WATTS BAR NUCLEAR PLANT (WBN) UNIT 1 - RESPONSE TO NRC QUESTIONS ON TVA'S
QA RECORDS CORRECTIVE ACTION PROGRAM (CAP) PLAN, REVISION 4

RESPONSE TO NRC QUESTIONS OF JANUARY 30, 1992

CONCERNING TVA'S QUALITY ASSURANCE RECORDS CAP (REVISION 4)

Figure 1. Bayes Examples (using flat prior on linear scale)

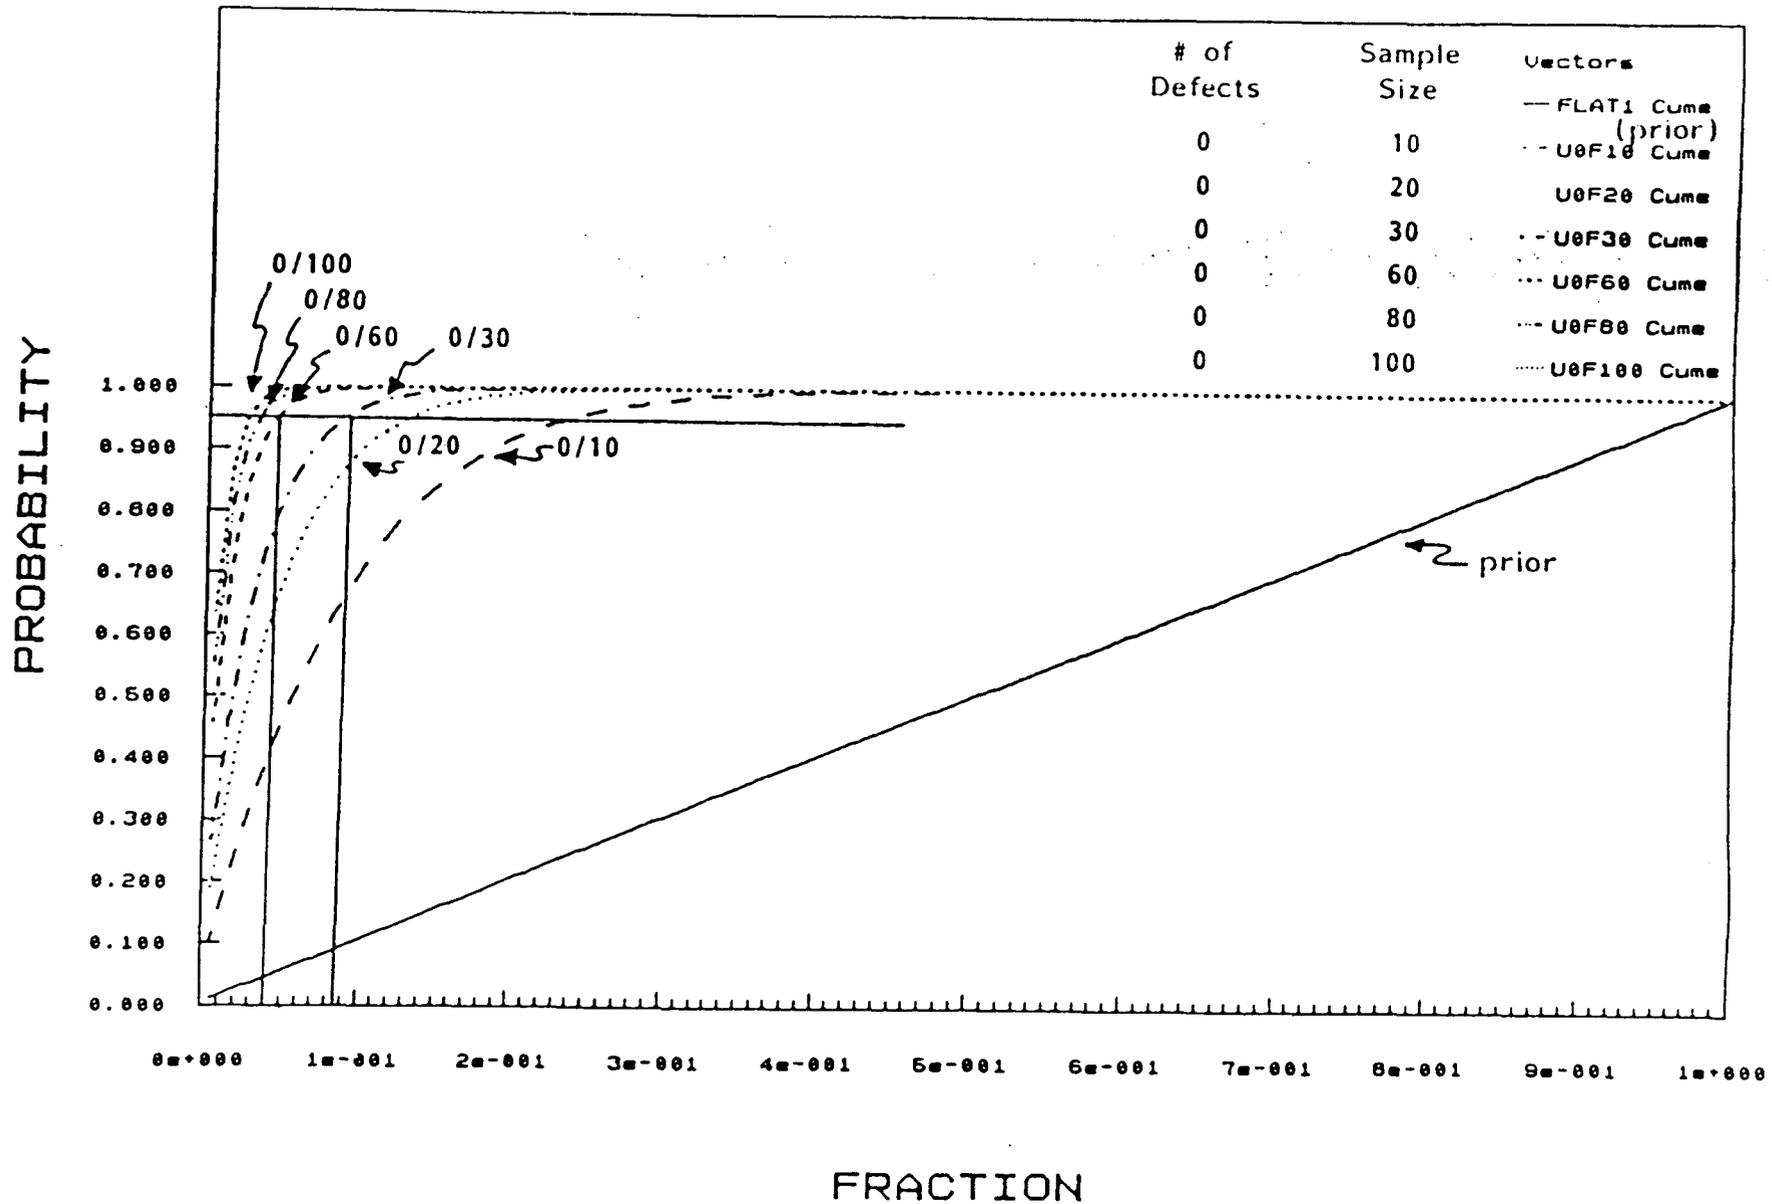
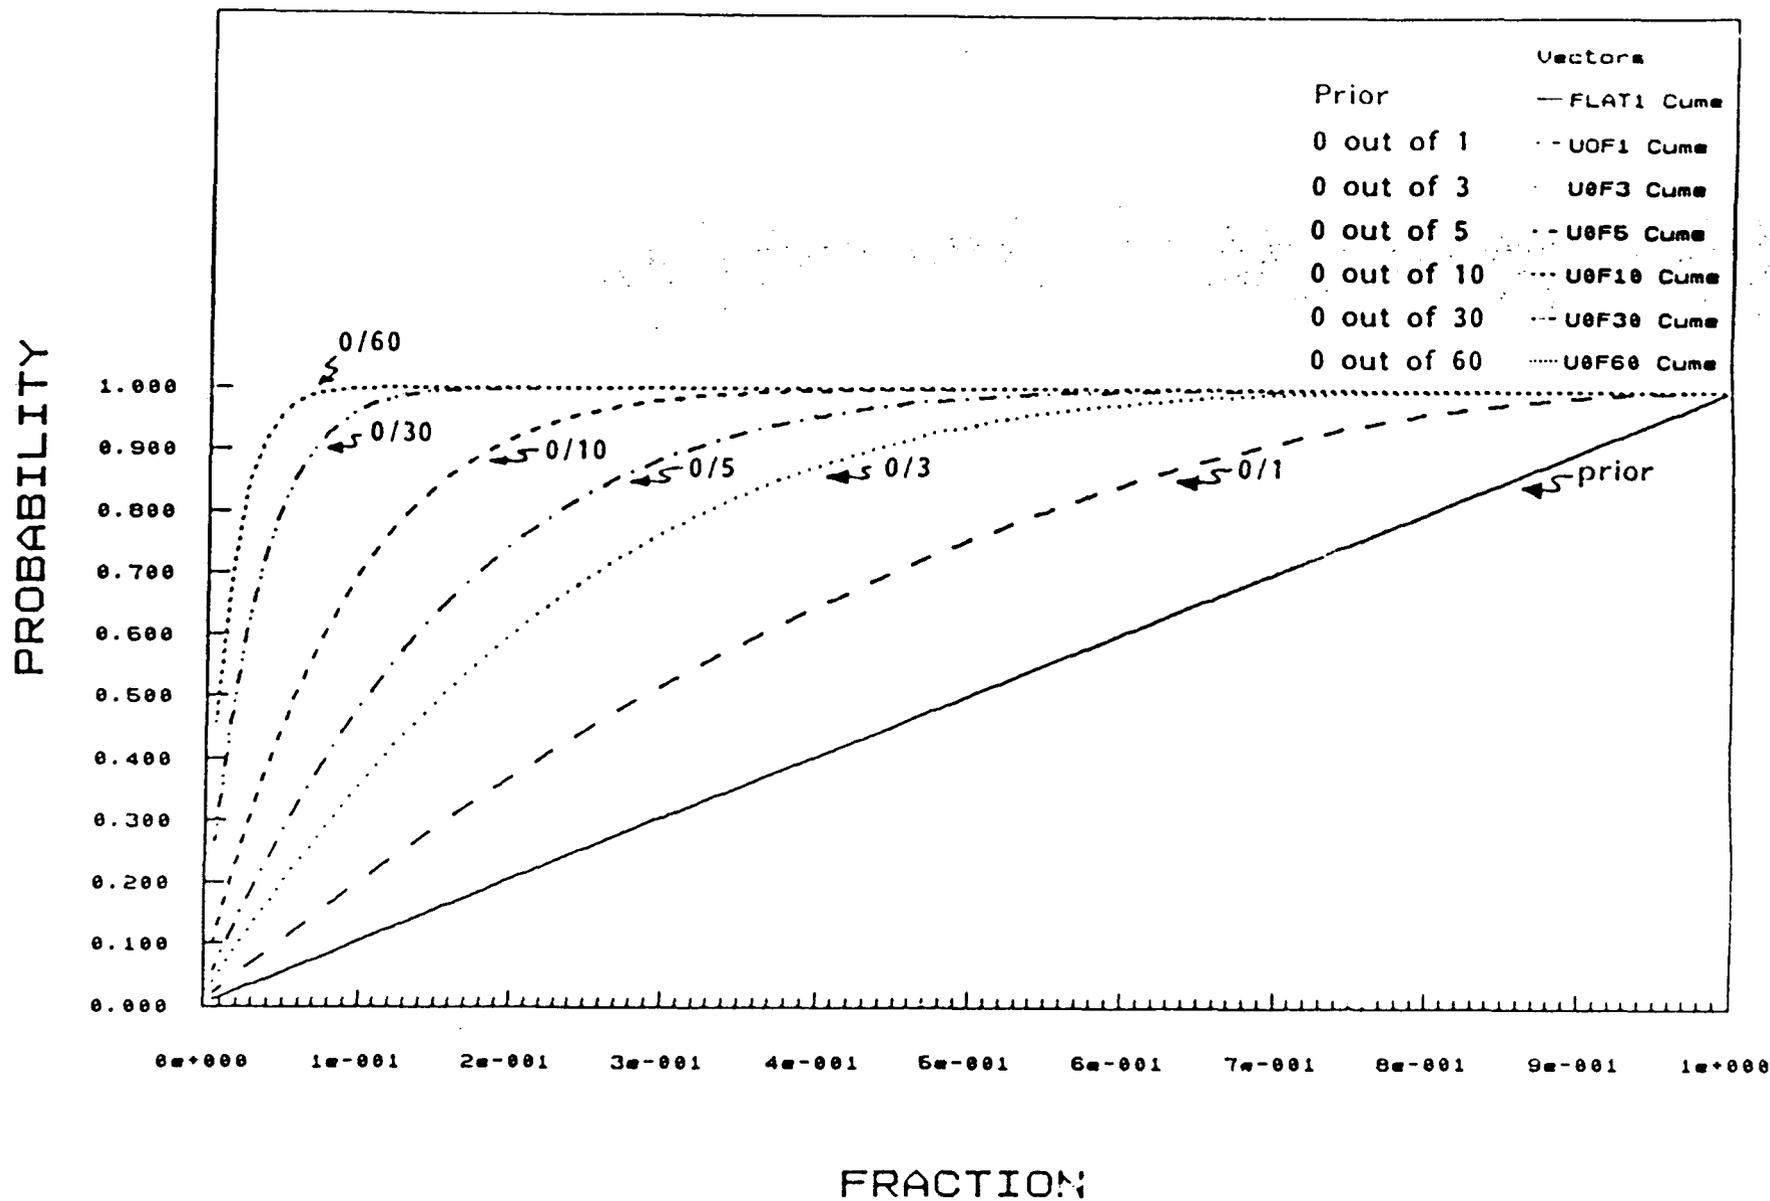
- (a) What is the justification for using a Bayesian as opposed to a standard classical approach?
- (b) What is the prior distribution of the defect fraction used to calculate the curves in Figure 2 of the reference? On what basis was it chosen?
- (c) What prior distributions will be used for the weighted average technique, and on what bases were they chosen?
- (d) What is the sensitivity of the results to the prior distributions used in (b) and (c) above?

The prior distribution used to calculate Figure 2 in Reference 3 of the May 10 letter, was a flat prior on a logarithmic scale between .001 and 1.0. This distribution was chosen, for this figure, just as a convenient way to give examples of Bayes theorem at work. It was not intended to reflect a realistic prior state of knowledge about any particular population, and in fact, simply by virtue of its flatness, is already somewhat unrealistic. The flat prior on the logarithmic scale says that, before we see any sampling results, we would give the same amount of credence to the prospect that the true defect fraction lies between .001 and .01 as we would give to the prospect that it lies between .01 and 0.1, and as we would give to the prospect that it lies between 0.1 and 1.0. In other words, it gives probability 1/3 to each of the three decades.

Figure 3. Ways to Get 95/5 Confidence--Classical

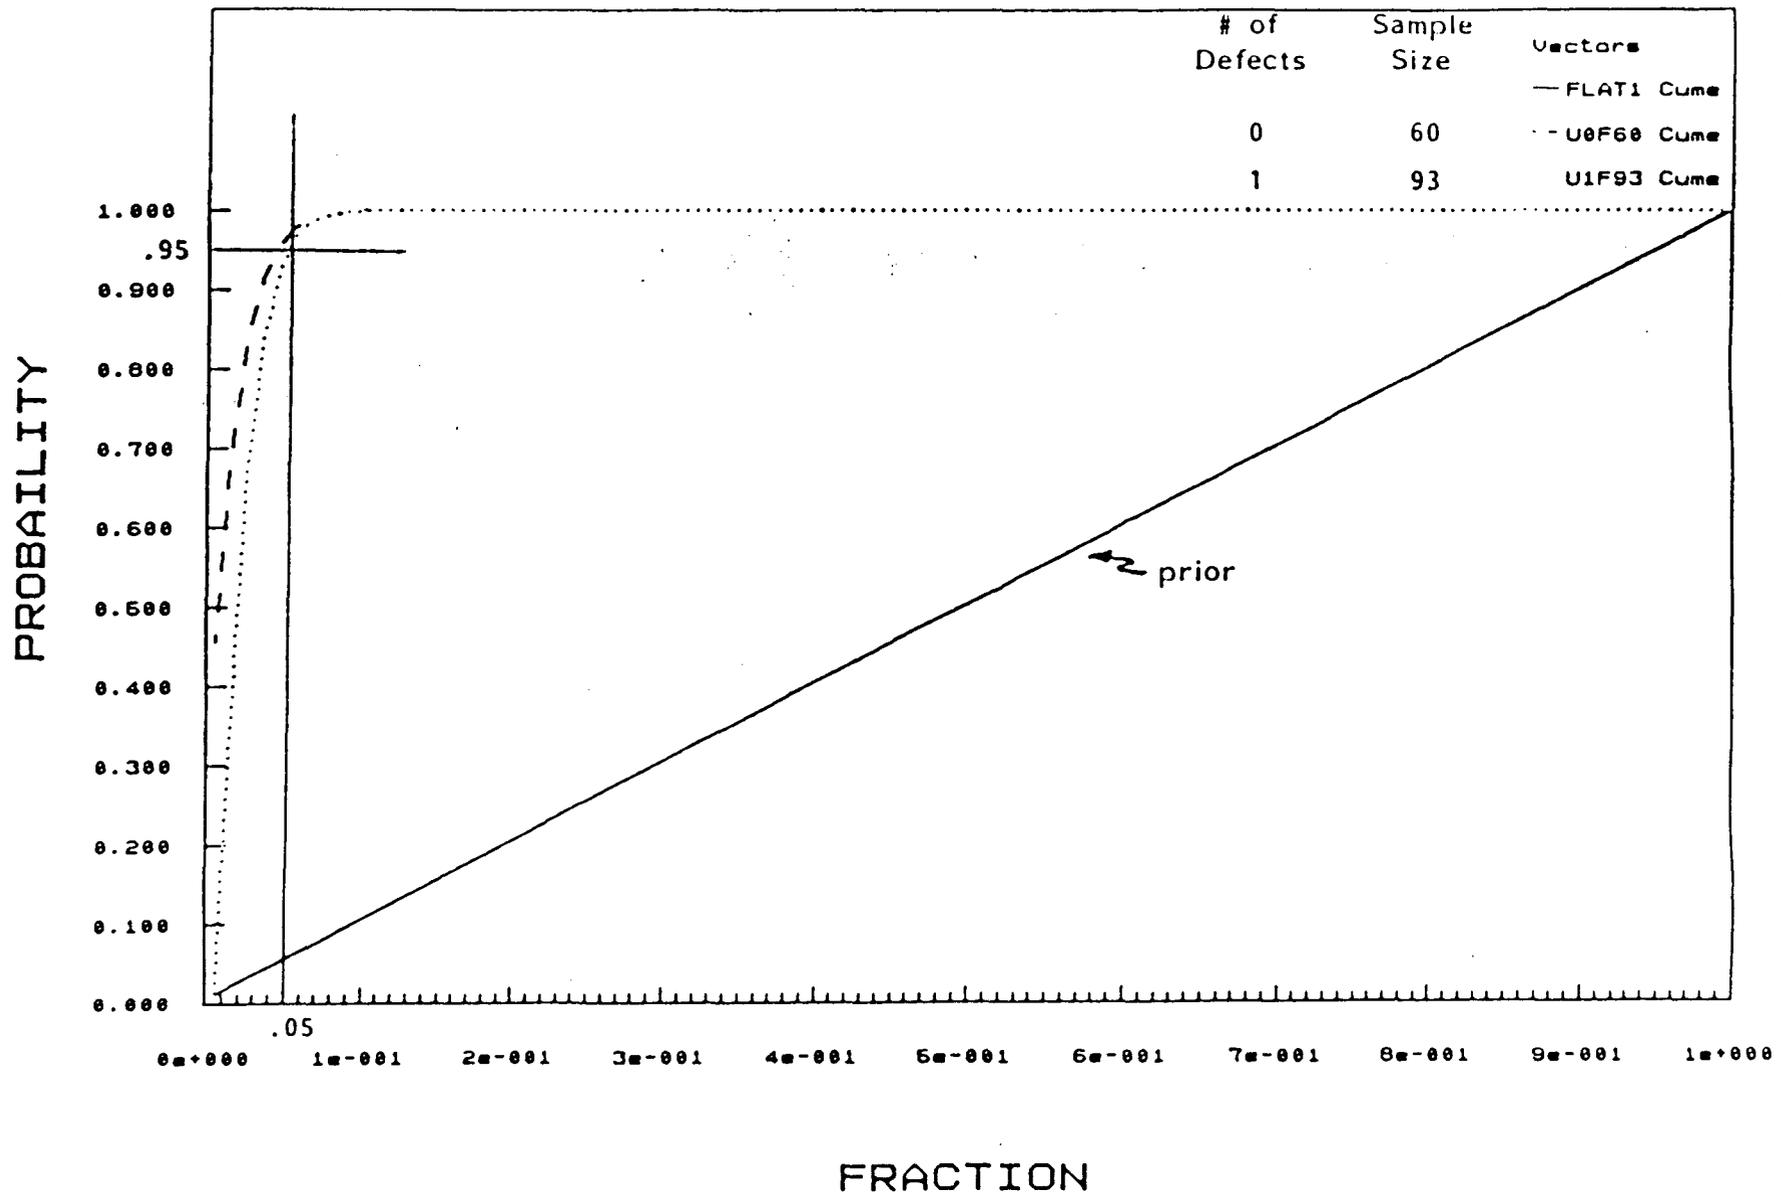
NRC QUESTION 14:

Using a standard classical probability approach, the last several sentences of the second paragraph of Section 2.e of the ASRR would be correct if they were revised as follows:

A 95 percent confidence that there are less than 5 [not 3] percent deficiencies in the remaining population (95/5) [not 95/3] could be established by finding no deficiencies in a sample of 60. Similarly, satisfying 95/3 could be established by finding no deficiencies in a sample of 100 [not 60]. Similarly, satisfying 95/5 could be established by finding less than or equal to one deficiency in a sample of 93 [not 60]. A 95/10 could be satisfied by finding less than or equal to three deficiencies in a sample of 75.

Bayes theorem is the fundamental law governing the process of logical inference. It therefore includes the drawing of inferences from sampling data. The standard classical approach, in fact, may be regarded as an example of the Bayesian approach. It is a special case of the Bayesian approach in which the prior is chosen as a flat distribution on a linear scale from zero to one. In order to demonstrate this, TVA has performed the Bayesian calculations for this type of prior to show that the numerical results agree with those standard classical results given by NRC in question 14. The numerical results, for zero defects found in various sized samples, are shown in figures 1 and 2. We see here, among other things, that as the standard approach says, zero defects in a size 60 sample gives us just over 95% confidence that the defect rate is less than 5%. Figure 3 shows, as NRC says, that one also has 95/5 confidence after a sample of size 93 in which one defect was found.

Figure 4. Ways to Get 95/10 Confidence--Classical

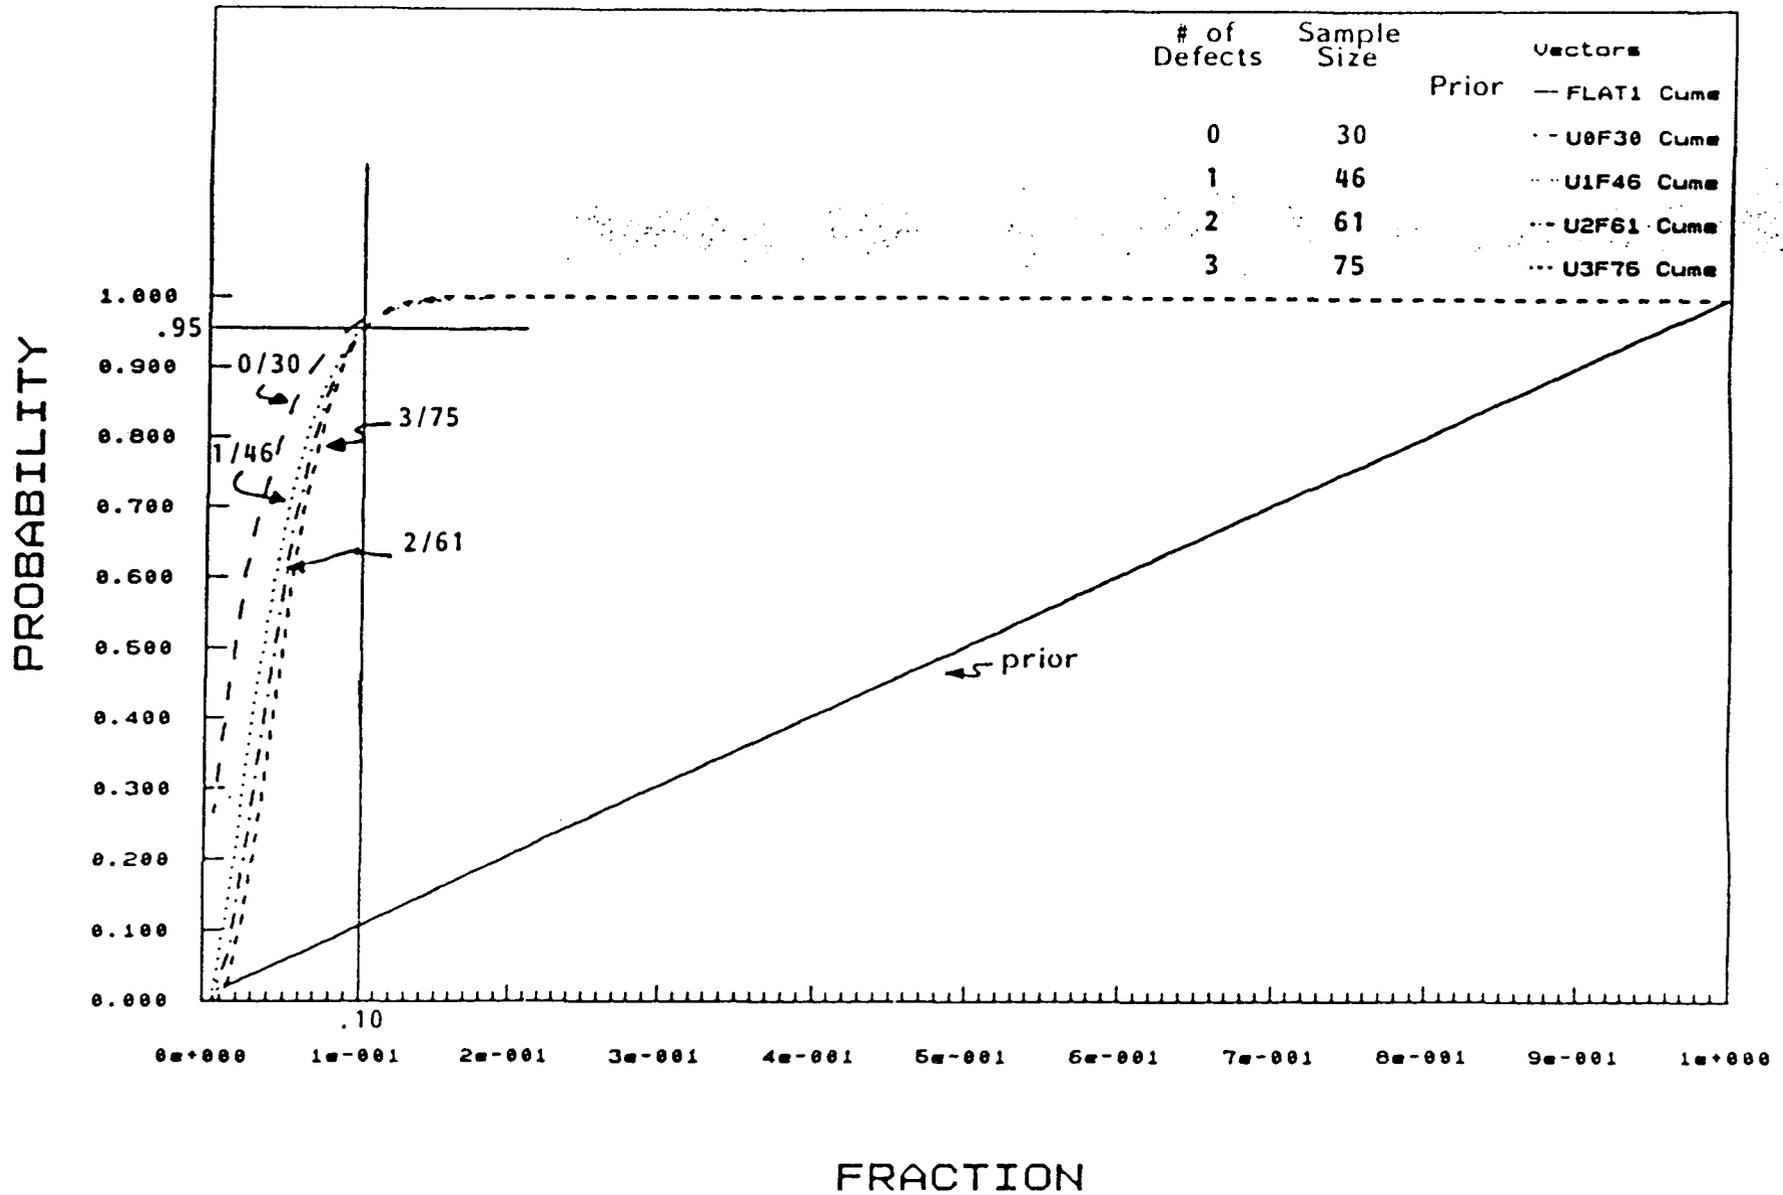
A 95/10 could be satisfied by less than or equal to two deficiencies in a sample of 61.

A 95/10 could be satisfied by less than or equal to one deficiency in a sample of 46.

A 95/10 could be satisfied by finding no deficiency in a sample of 30.

Figure 4 shows, again in agreement with NRC's question 14, that 95/10 can be established with zero out of thirty, one out of forty-six, two out of sixty-one, or three out of seventy-five.
